## WARRANTY BULLETIN

### WB14-28E

DATE :	OCTOBER 2014	SECTION :	23 - Accessories
EXPIRATION:	OCTOBER 2016		
SUBJECT :	AFSS LINEAR THERMAL DETECTOR (LTD) REPLACEMENT AND RELOCATION OF IR SENSOR

FIGURE 11: IDENTIFICATION OF COMPONENTS AND HARNESSSES

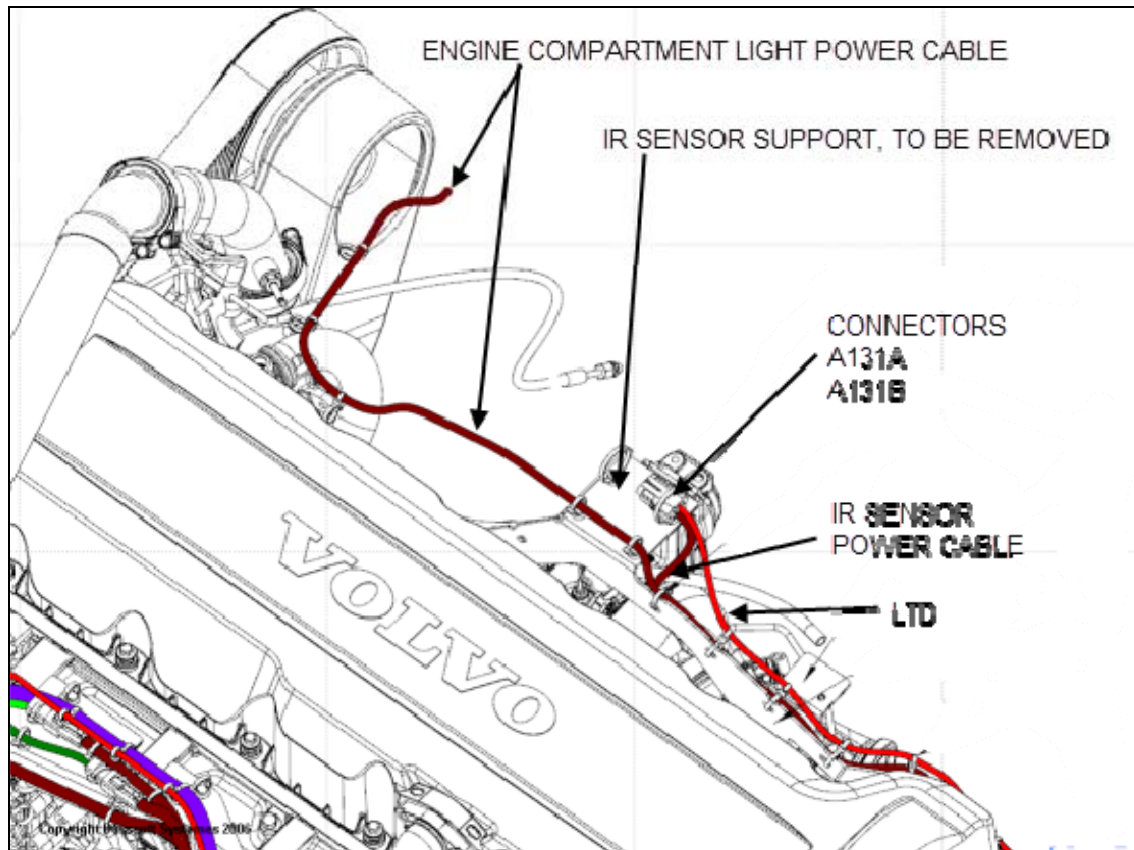
- 1) Locate the IR sensor and support above the turbo (FIGURE 11).
- 2) Disconnect A131A & A131B at the IR sensor (A, FIGURE 12).
- 3) Cut the nylon cable ties along the support and cut the nylon cable ties securing the engine compartment light cable up to the light (B, FIGURE 12).

FIGURE 12

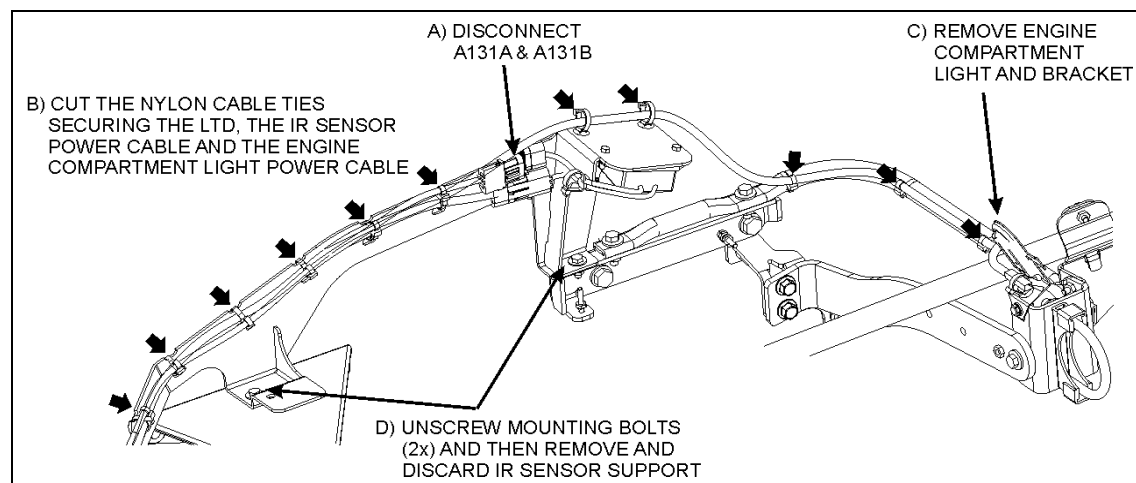
- 4) Remove and discard the engine compartment light and bracket (C, FIGURE 12).
- 5) Remove and discard the IR sensor support (D, FIGURE 12).

FIGURE 13

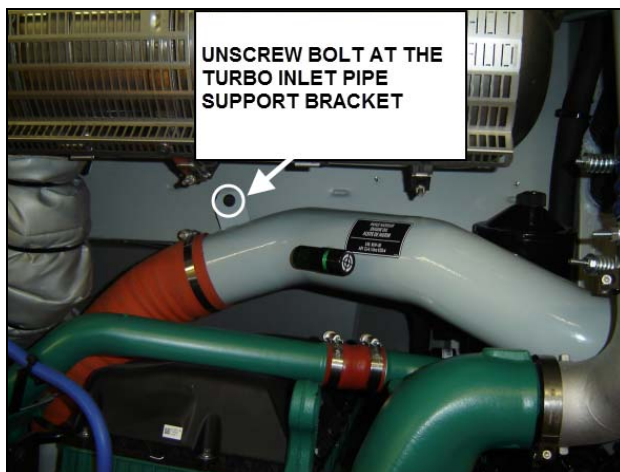
- 1) Unscrew the bolt at the turbo inlet pipe support bracket (FIGURE 13).
- 2) Mount the new IR sensor onto the new support #406701 (FIGURE 14). Install IR sensor and support assembly onto turbo inlet pipe support bracket as per FIGURE 13. Take note that the sensor cables must be placed on the exterior side of the engine compartment.

FIGURE 15

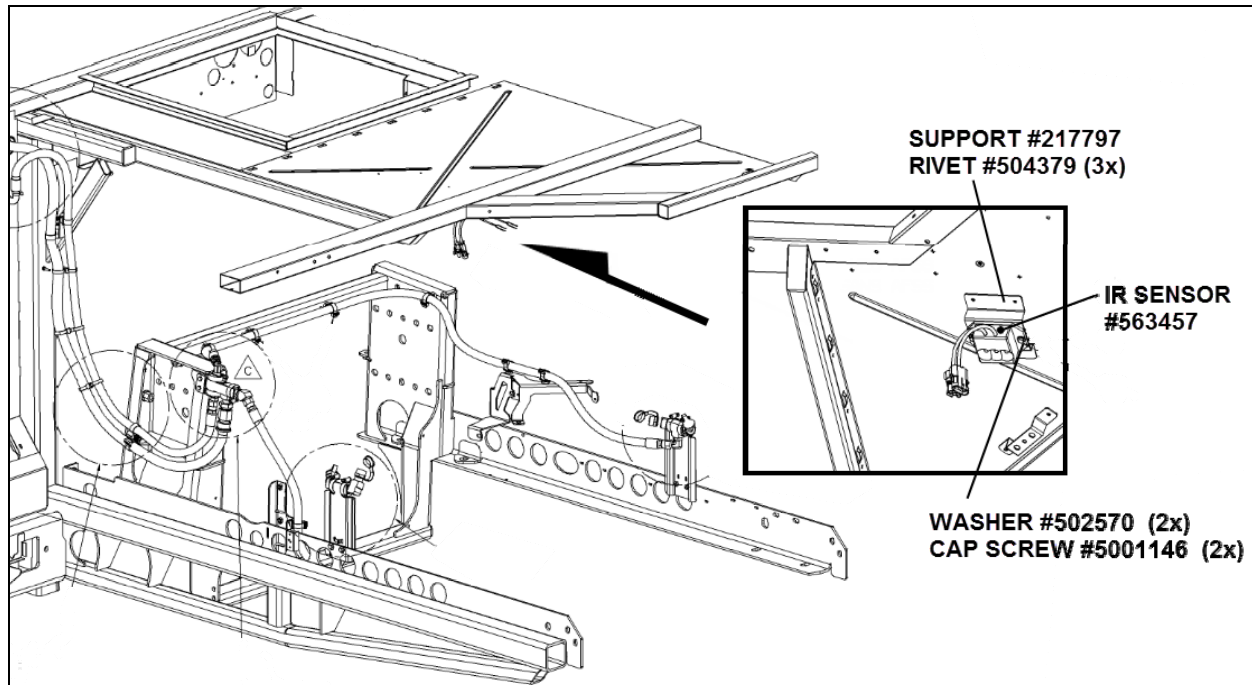
- 1) Install the new IR sensor at new location as shown on FIGURE 15. The IR sensor will be installed on the stainless steel panel on top of the engine.

FIGURE 16

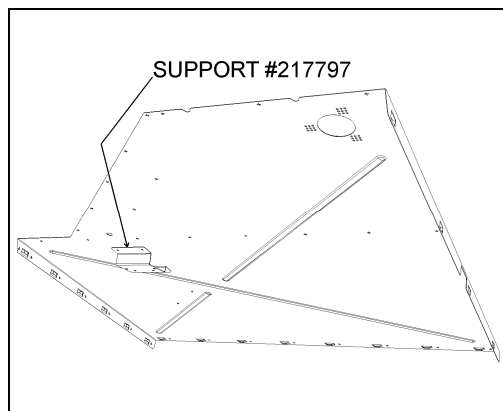
- 2) First, install support #217797 as shown on FIGURE 16. Locate the support according to measurements of FIGURE 17.
- 3) Pre-drill three 7/32" holes for the installation of the support. Secure support using three pop rivets #504379.

**FIGURE 19: REMOVE LTD**

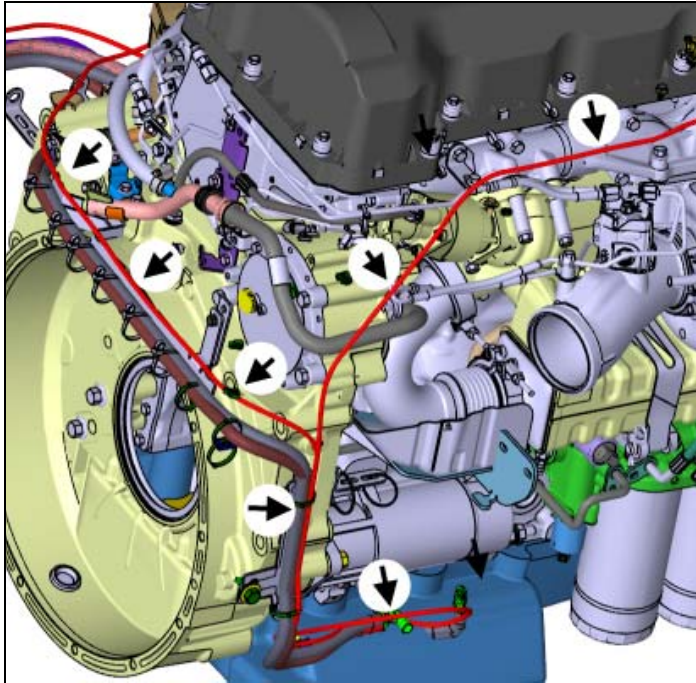
- 1) Cut all nylon cable ties and remove the entire LTD (cable with red sheath). On the engine hot side, the LTD may be routed under the starter and forms a loop and then comes back and runs to the cold side of the engine (FIGURE 19). On the cold side, the LTD is routed as shown on FIGURE 20. Keep the termination (a.k.a. EOL End of Line device) connector found at the end of the LTD for reused.

FIGURE 21: CUT THE HARNESS CLOSE TO THE BRACKET

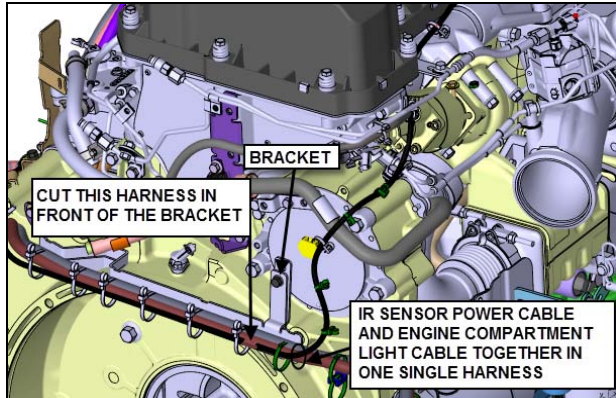
- 1) The engine compartment light power cable and the IR sensor power cable are joined together in one single harness. Locate this harness and cut it close to the bracket shown on FIGURE 21. Discard the section of this harness that runs on the turbo side.

Figure 26

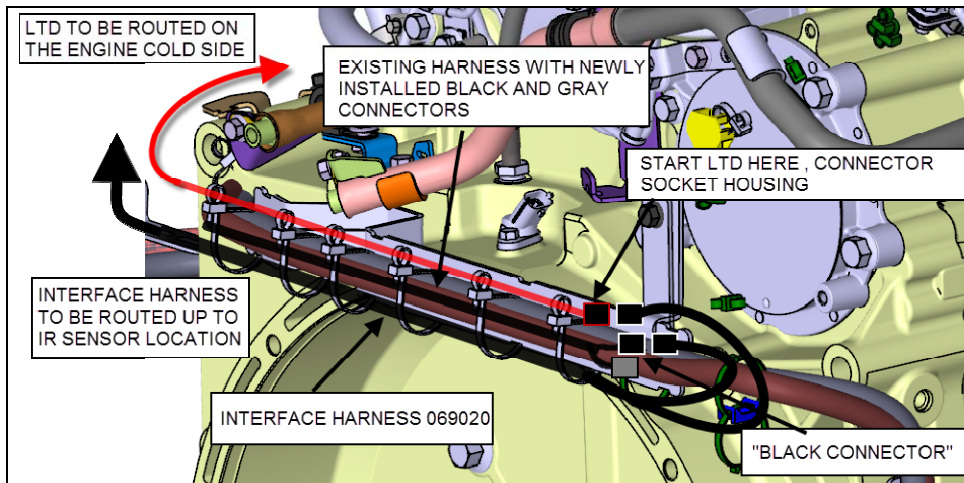
- 1) Secure LTD to existing harness (see Figure 26 for proper installation) using 6 double loop head nylon cable ties 507664. Use the second loop to attach the LTD (Figure 26 and Figure 27). Tighten the loop fixing the LTD by hand only. Follow the general recommendations.

FIGURE 31

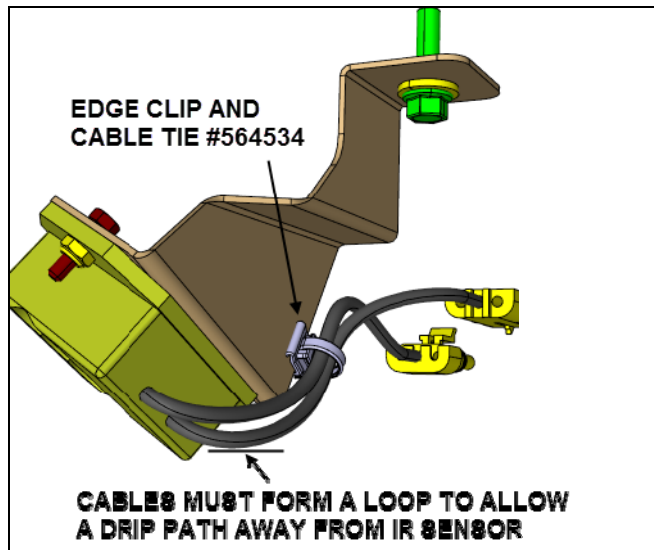
- 3) Connect the interface harness to the IR sensor. Secure IR sensor connectors as shown on FIGURE 31 and FIGURE 32 using 5 screws 501017 (pre-drilling diameter= 1/8 in ), 5 flat washers 500964, 5 tie mounts 504013, 5 nylon cable ties 504637 and 1 edge clip 564534. The IR sensor cables must form a loop to allow a drip path away from the IR sensor.

FIGURE 34

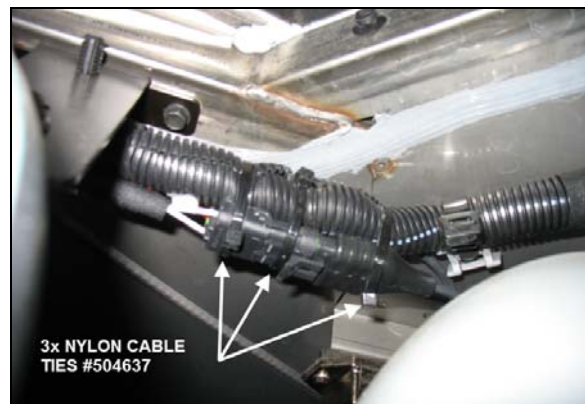
- 2) Connect the interface harness to the IR sensor (FIGURE 33).
- 3) Secure the interface harness connectors to close existing harness using three nylon cable ties #504637. The IR sensor cables must form a loop to allow a drip path away from the IR sensor (FIGURE 33, FIGURE 34).
- 4) Put fuse F45 back in place. Set the battery master switch to the ON position.
- 5) Set the ignition switch to the ON position and check that the driver's area AFSS protection panel SYSTEM OK green lamp is illuminating and that no fire detected/extinguisher discharge condition has been triggered. If no Kidde valve simulator is installed, the TROUBLE lamp should illuminate steady, indicating there is a fault in the extinguishing circuit, which is normal if the extinguisher circuit is not connected to the extinguisher bottle. The TROUBLE lamp will blink if there is a fault in the detection circuit.
